Date: 04.27.21
Project: Cynosure / Wild Ridge
City of Dripping Springs
Parkland Dedication Plan

MEMORANDUM

This memo serves as follow-up correspondence to the April 2021 preliminary review by LUCK Design Team, LLC of the Cynosure /Wild Ridge Parkland Dedication Plan submitted March 23, 2021. Please reference Parkland Dedication Plan Narrative and site plans.

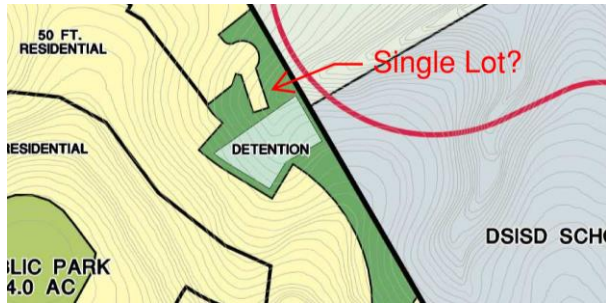
7. The east of the tract fronts Rathgeber Natural Resource Park and the future DSISD School Site. There is a single lot in this area. Please describe the intent of this area. (See image below.) Will kids be using it as a secondary access to the school? Will there be fencing around the detention pond or on the backside of the school to limit access? Can the single lot be eliminated to allow more frontage access to the school? Thank you for clarification in this area.
